Master Development Drainage Plan and  
Preliminary Drainage Report

**Peerless Farms**  
**16975 Falcon Hwy**  
**Peyton, CO 80831**

Project #: 19611400

PCD File No. SP-21-7

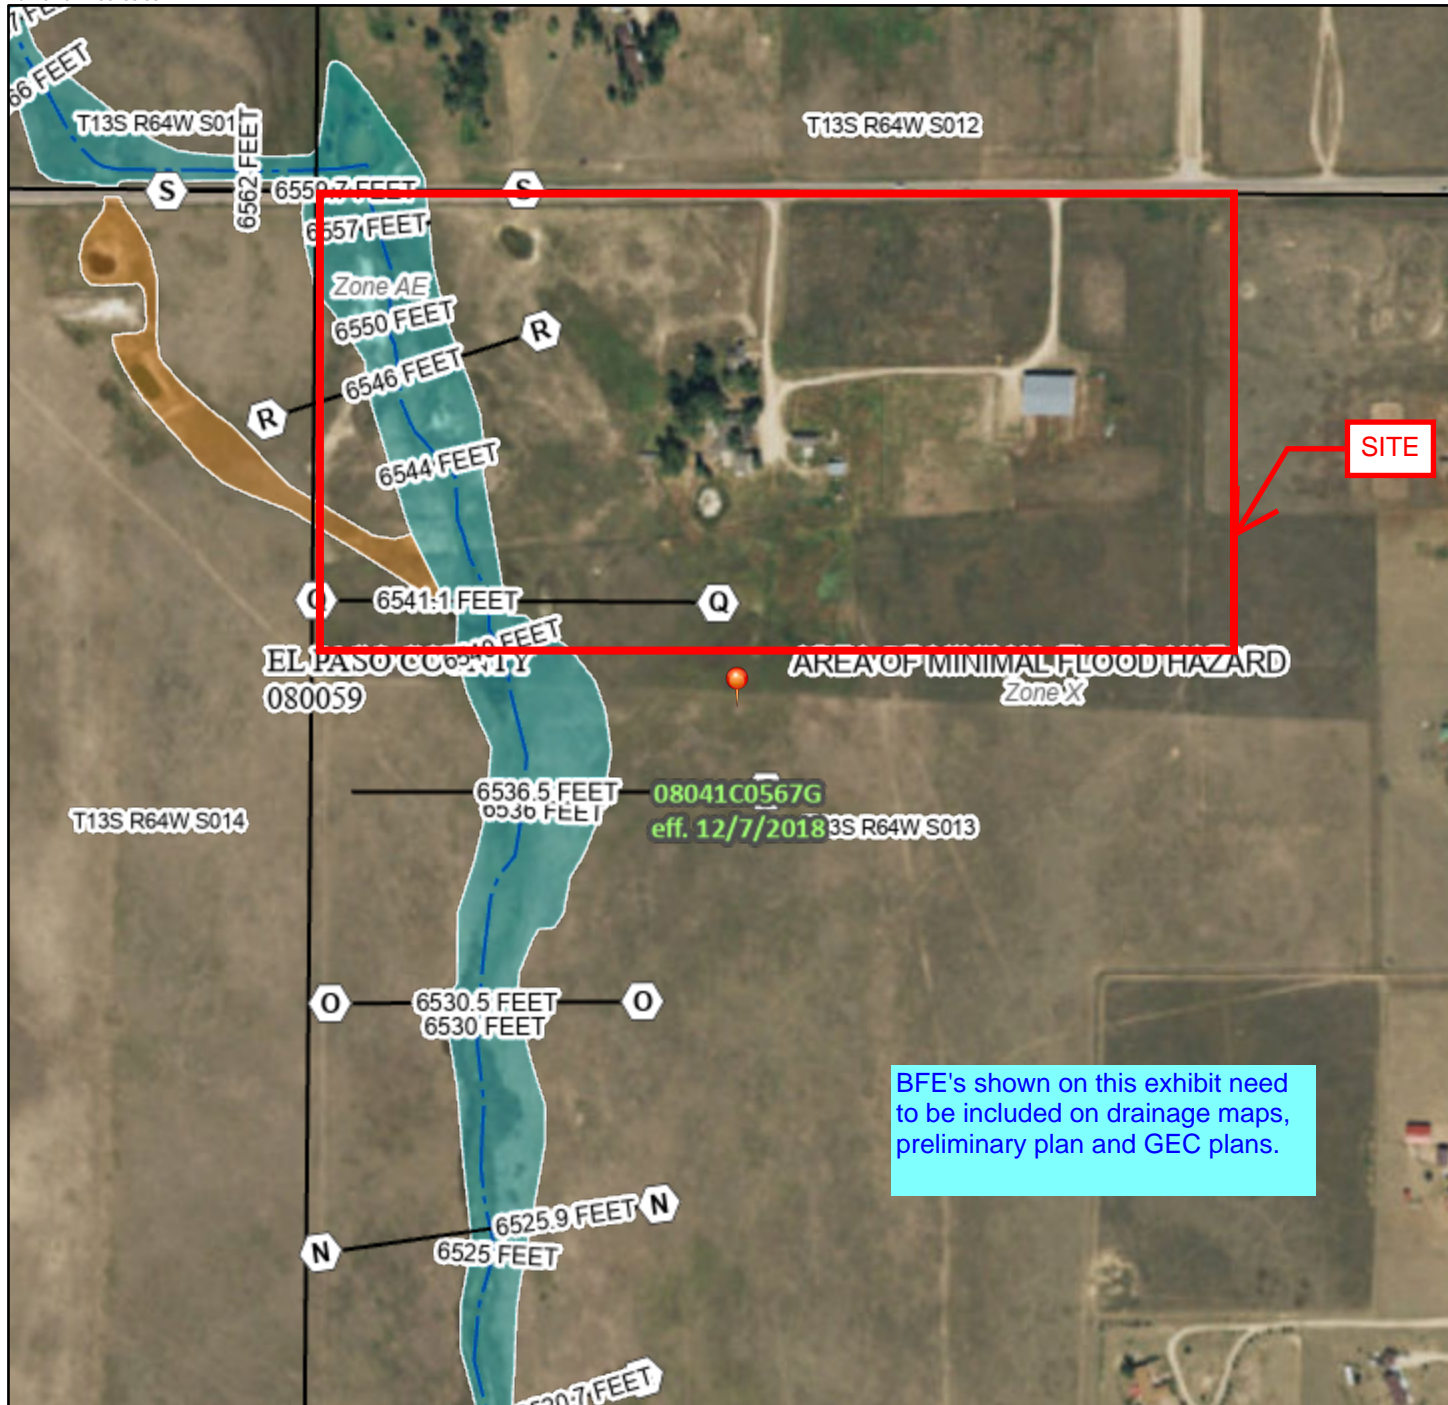
BFE's shown on this exhibit need to be included on drainage maps, preliminary plan and GEC plans.

K:\COS\_LA\196114000 - Peerless Farms\CADD\Exhibits\Existing Drainage Map.dwg

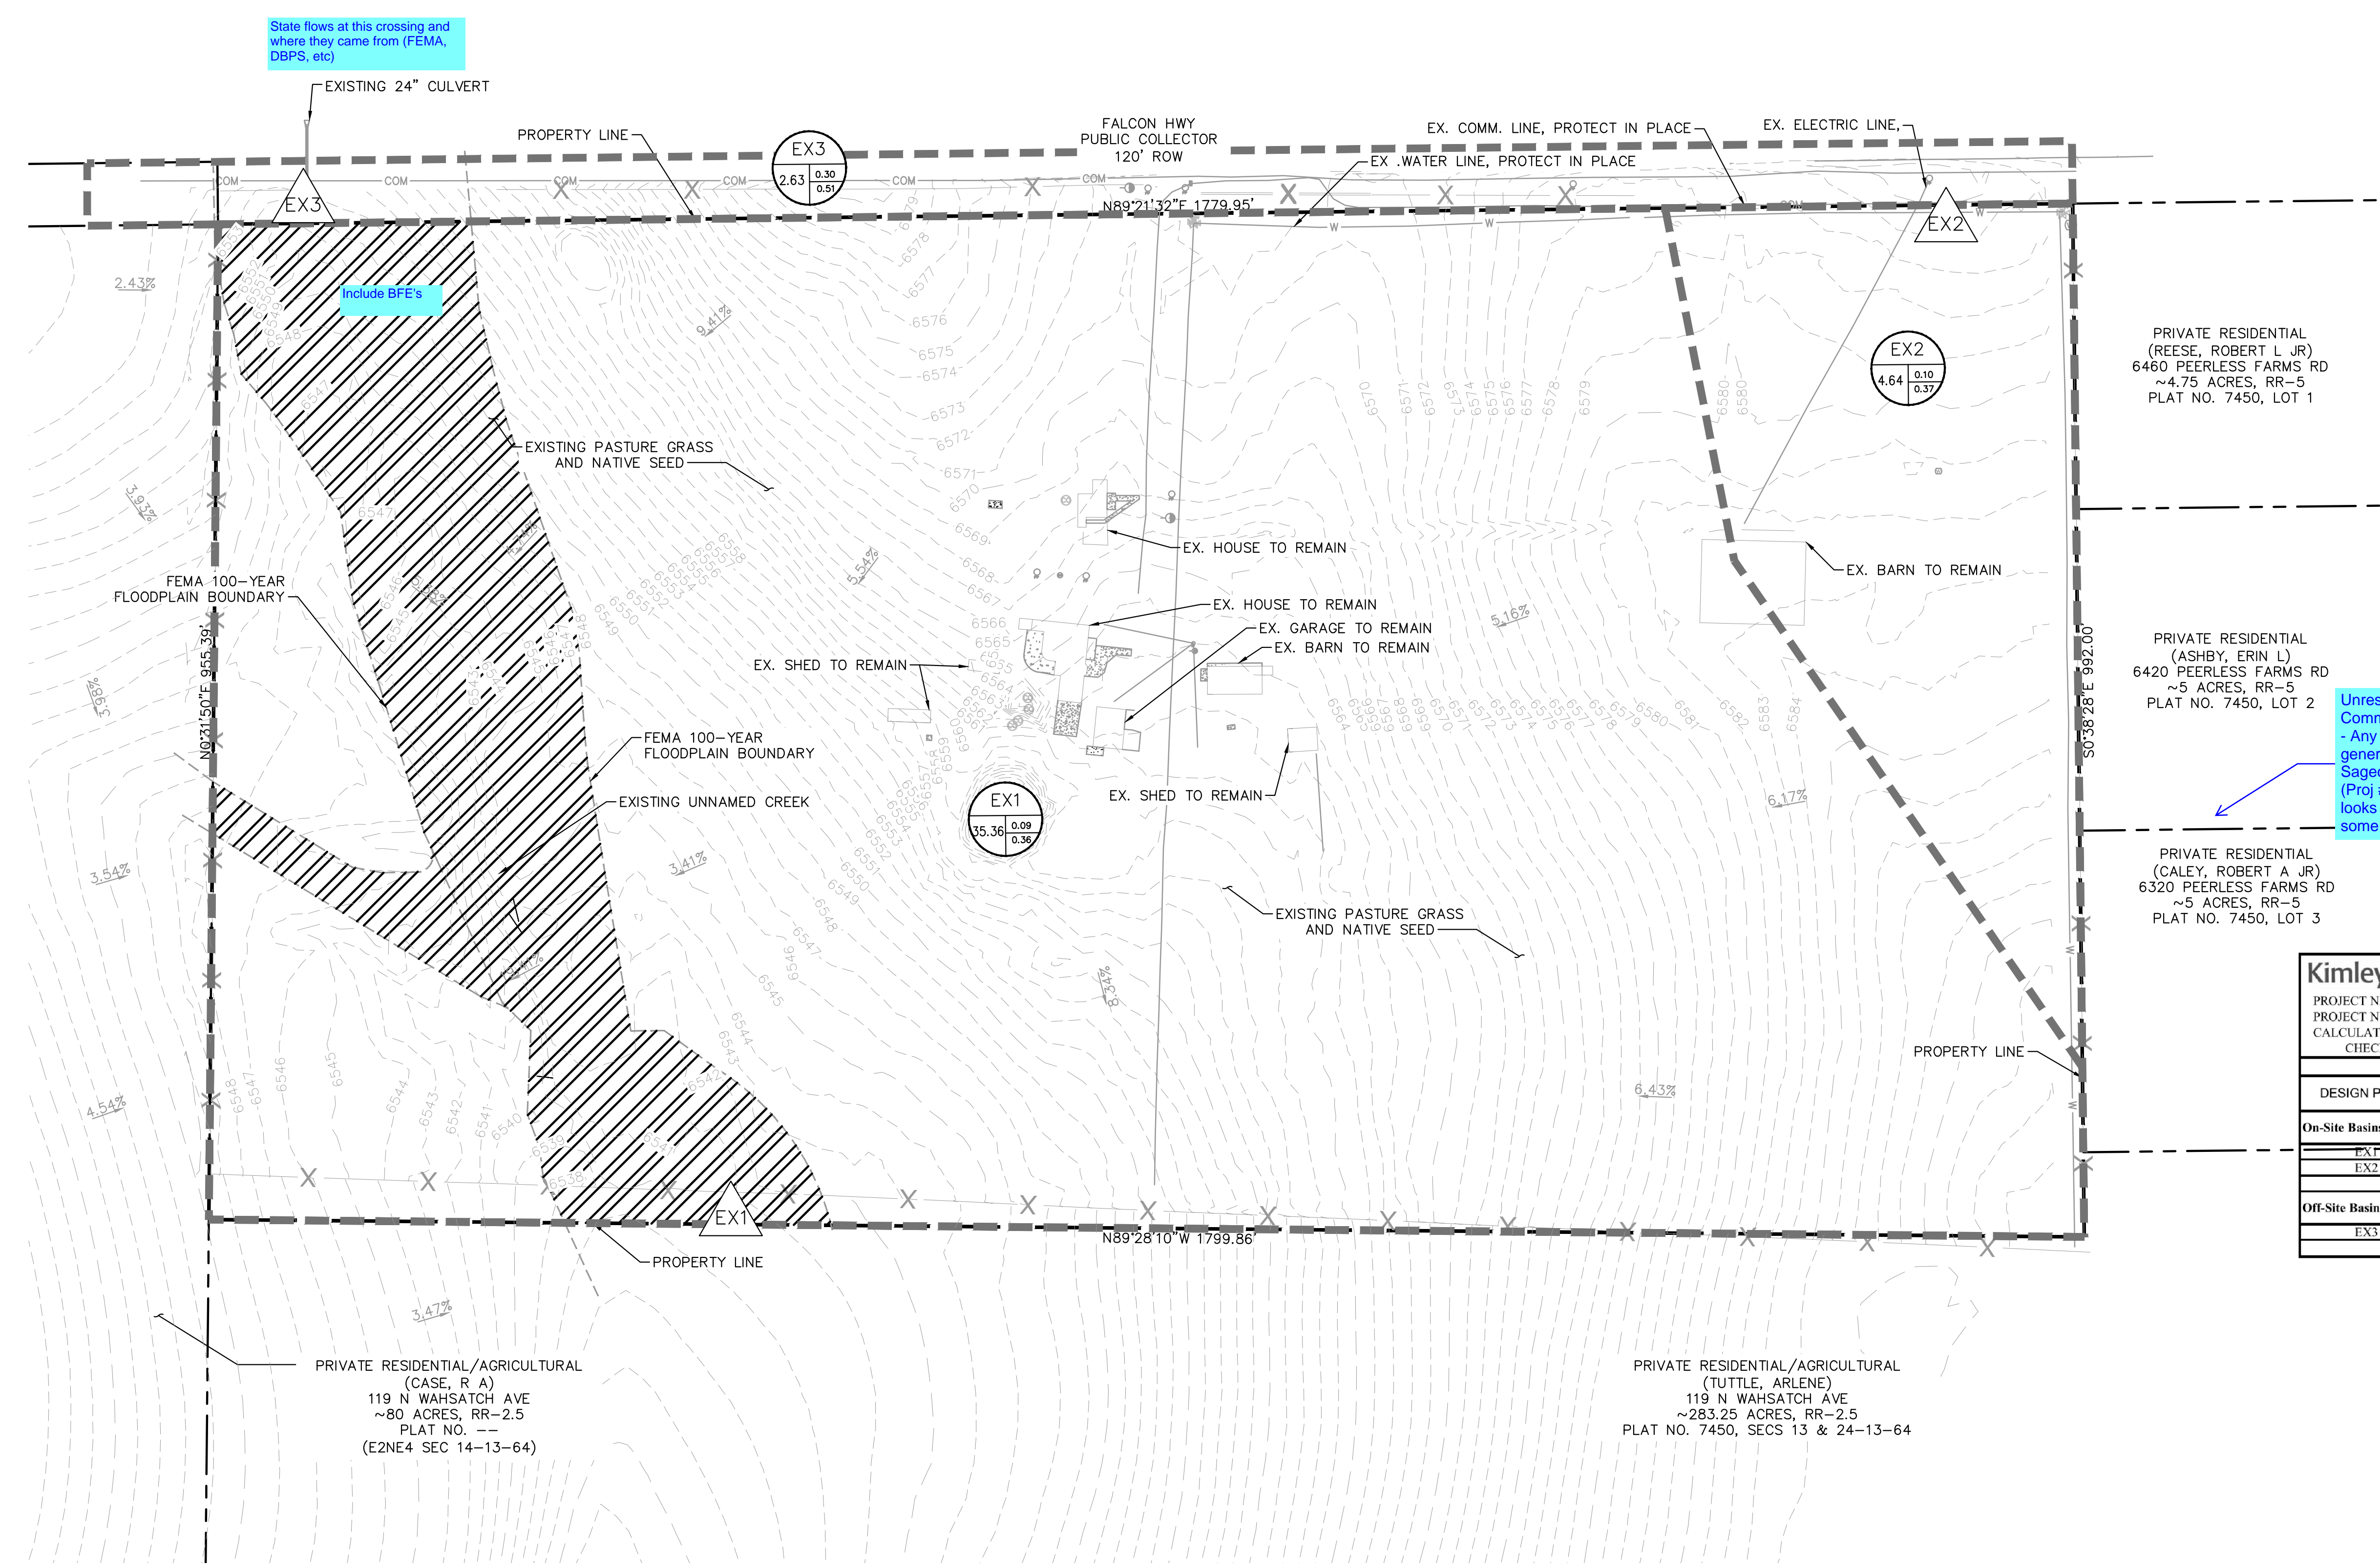
**Unresolved Review 1**  
 Comment:  
 - Any offsite flow from this general area? From Sagecreek South Drainage (Proj # SF85026) Map it looks like there may be some flow from here.

PROPOSED DRAINAGE MAP  
 PEERLESS FARMS  
 06/15/2023

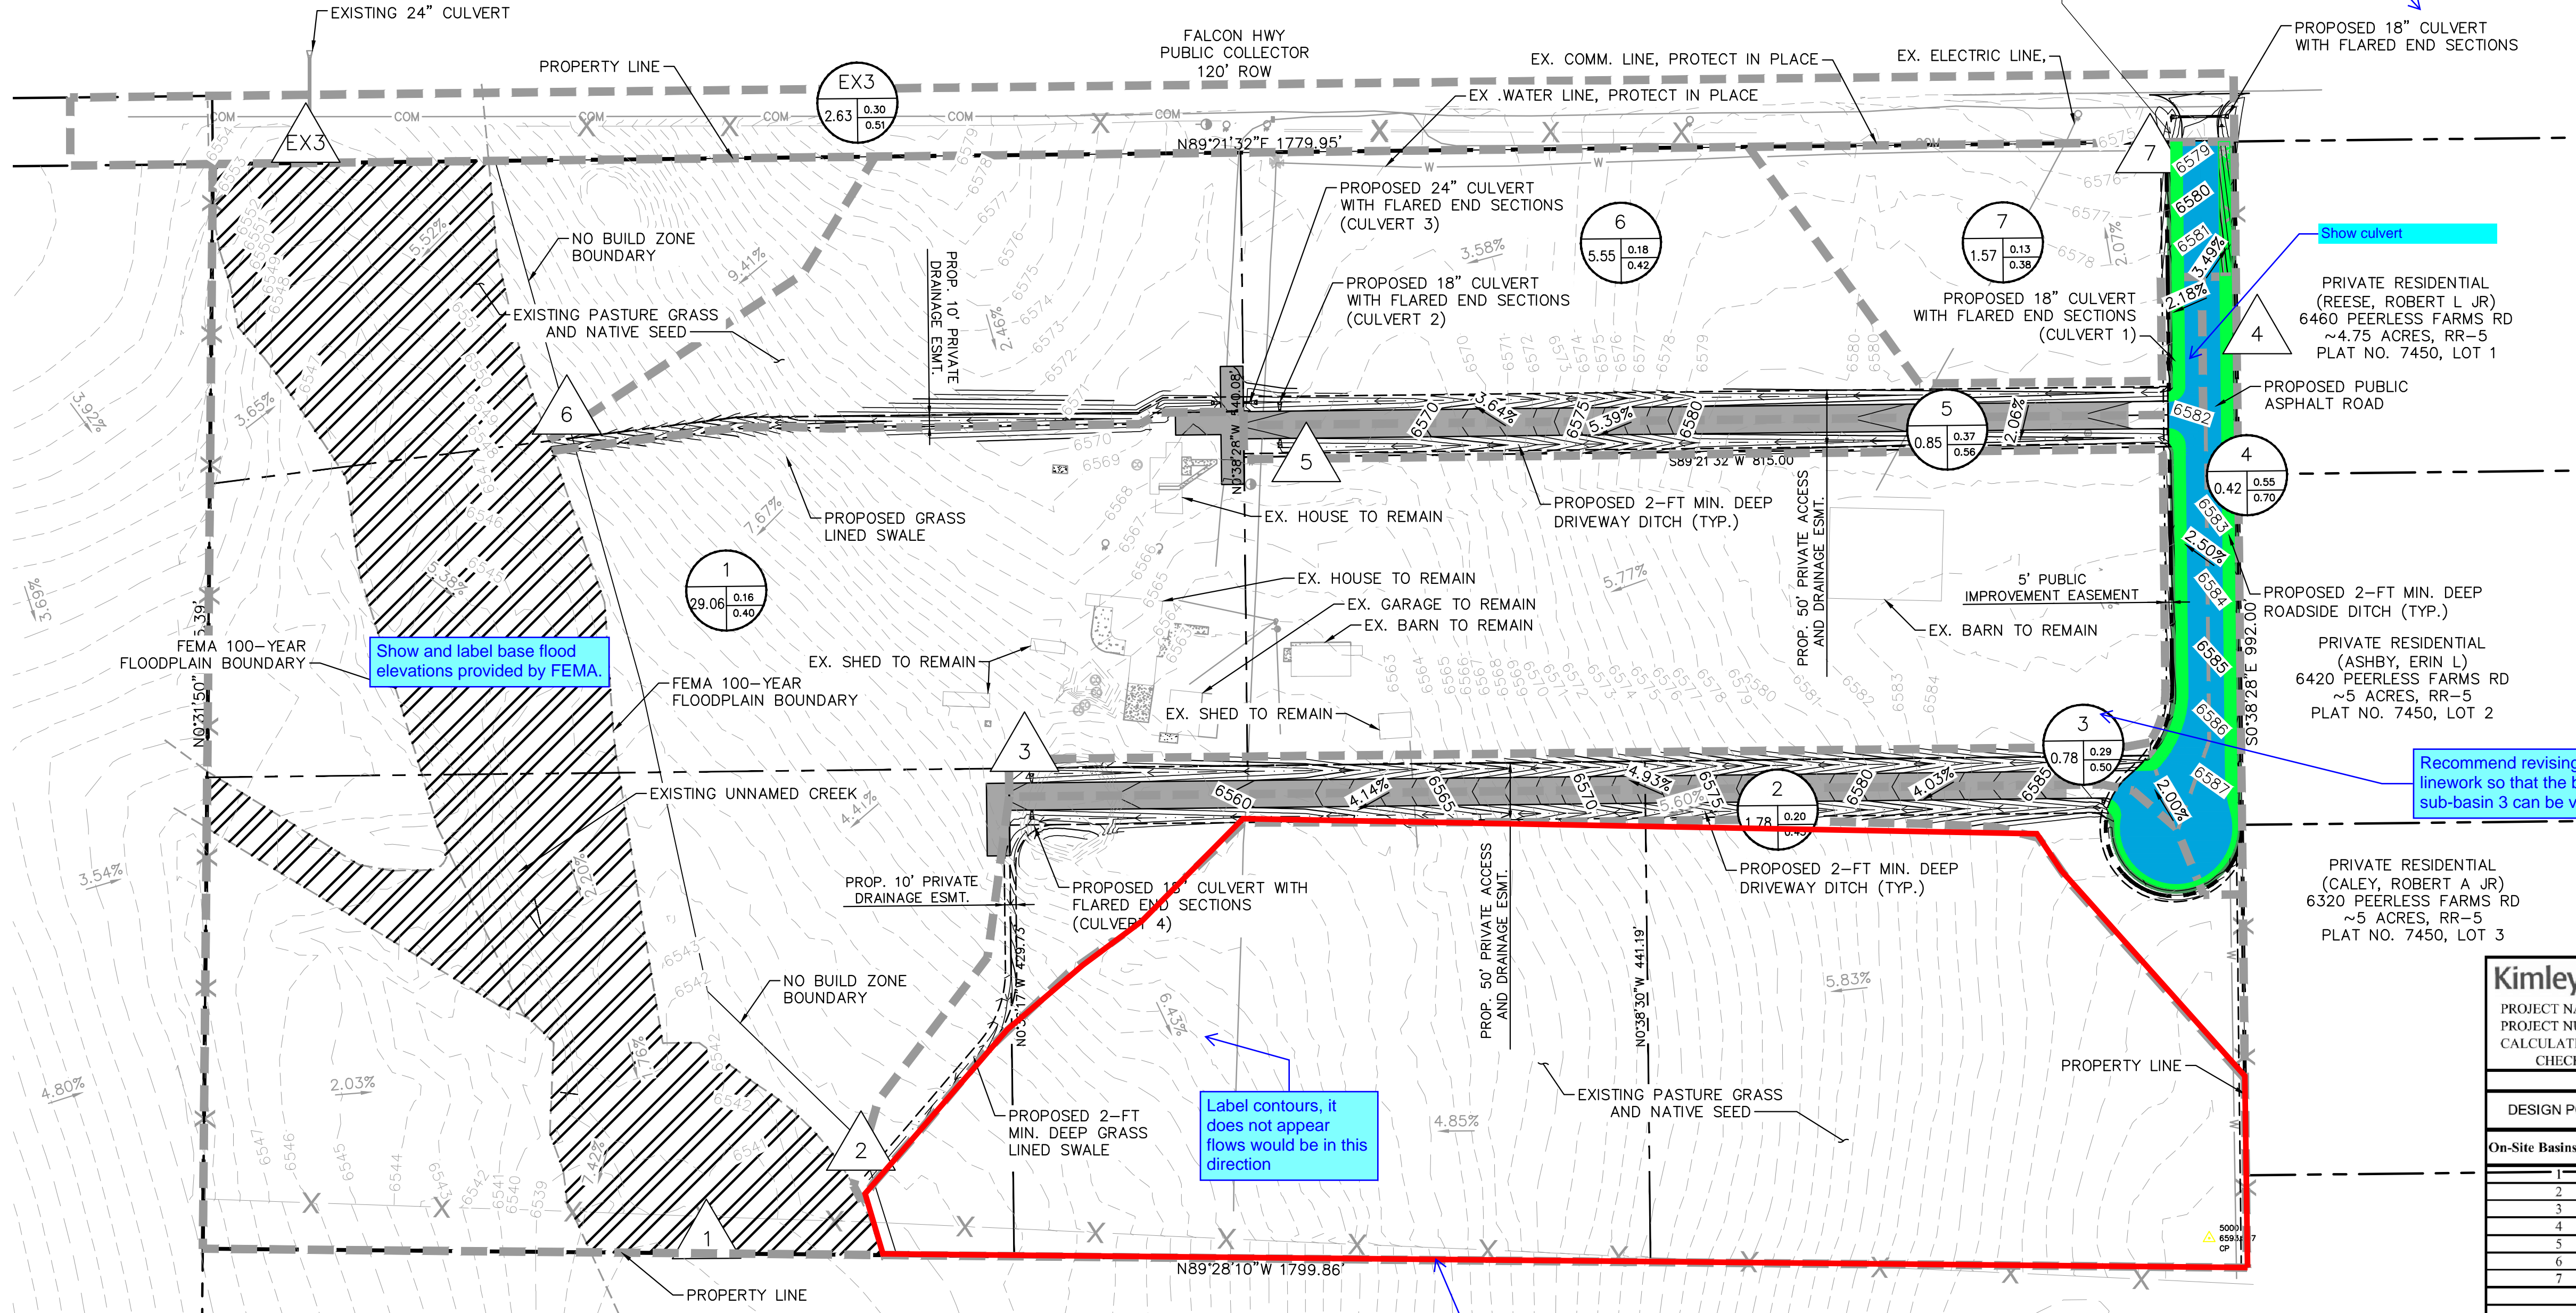
Show riprap outlet protection. Calculations will need to be provided with final drainage report.

Label UIA/RPA and SPA areas to correlate with UD-BMP Spreadsheet. you may want to create a new figure so that you can show dimensions and not clutter this figure.

Provide calculations for this culvert.

Label High points & low points

Recommend revising basin boundary line work so that the boundary of sub-basin 3 can be visible.

Show and label base flood elevations provided by FEMA.
